UNITED STATES PATENT AND TRADEMARK OFFICE

APPLICATION NO.	FILING DATE	FIRST NAMED INVENTOR	ATTORNEY DOCKET NO.	CONFIRMATION NO.
10/707,574	12/22/2003	Gerard H. ROUSSEAU	117424	1573
27074	7590	06/28/2005	EXAMINER	
OLIFF & BERRIDGE, PLC. P.O. BOX 19928 ALEXANDRIA, VA 22320			COLILLA, DANIEL JAMES	
			ART UNIT	PAPER NUMBER
			2854	
DATE MAILED: 06/28/2005

Office Action Summary	Application No. 10/707,574	Applicant(s) ROUSSEAU ET AL.	
	Examiner Daniel J. Colilla	Art Unit 2854

DETAILED ACTION

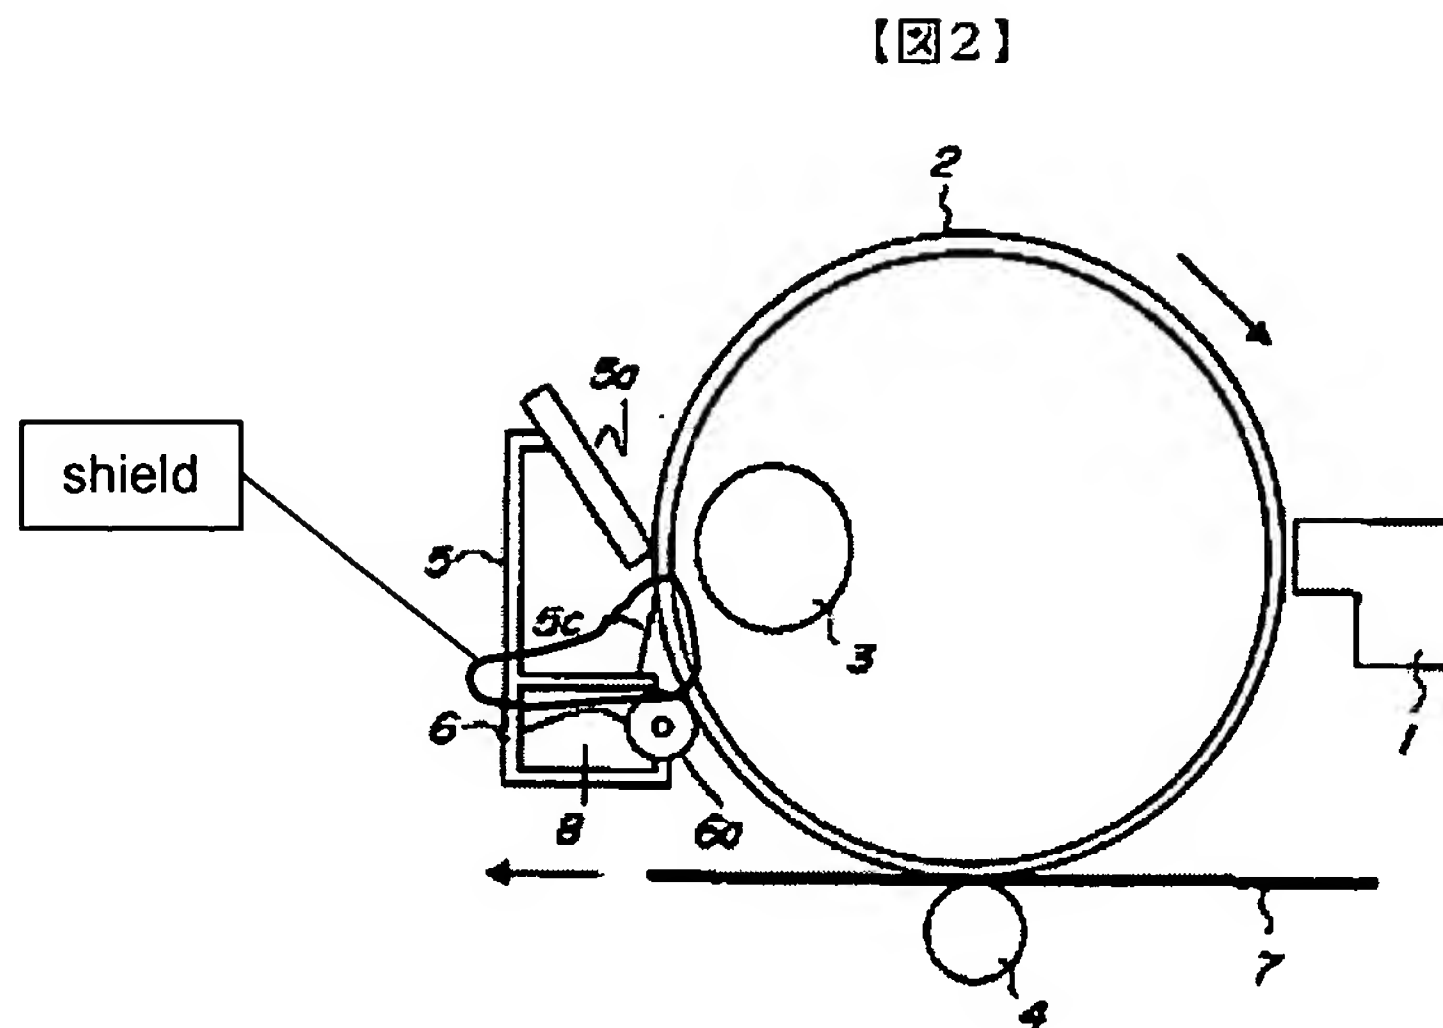
With respect to claim 1, Arai discloses a drum maintenance unit including a casing 5, an oiling roller 5b housed within the casing 5, a metering blade 5a at least partially housed in the casing and spaced from the oiling roller 6a and a shield formed by element 5c and a horizontal portion disposed between the oiling roller and the metering blade 5a as shown below in the Figure taken from Figure 2 of Arai:

With respect to claim 3, the shield forms a physical barrier between the oiling roller 6a and the metering blade 5a as shown above.

With respect to claim 4, the shield is used for scooping up and saving material 8 that is scraped off of oiling roller 6a. The shield would have to have a longitudinal length of the oiling roller in order to effectively collect and save the material 8 from the entire length of the oiling roller 6a.

With respect to claim 5, as shown above, the horizontal portion of the shield is on contact with the oiling roller 6a at its right end.

With respect to claim 9, the shield partially encases the oiling roller 6a as shown in the above Figure.

With respect to claim 10, the shield generally “L” shape as shown above.

With respect to claim 18, Arai discloses a method for reducing ink transfer to an oiling roller in a drum maintenance unit including the step of providing a shield as shown in the Figure above between the oiling roller 6a and the metering blade 5a.
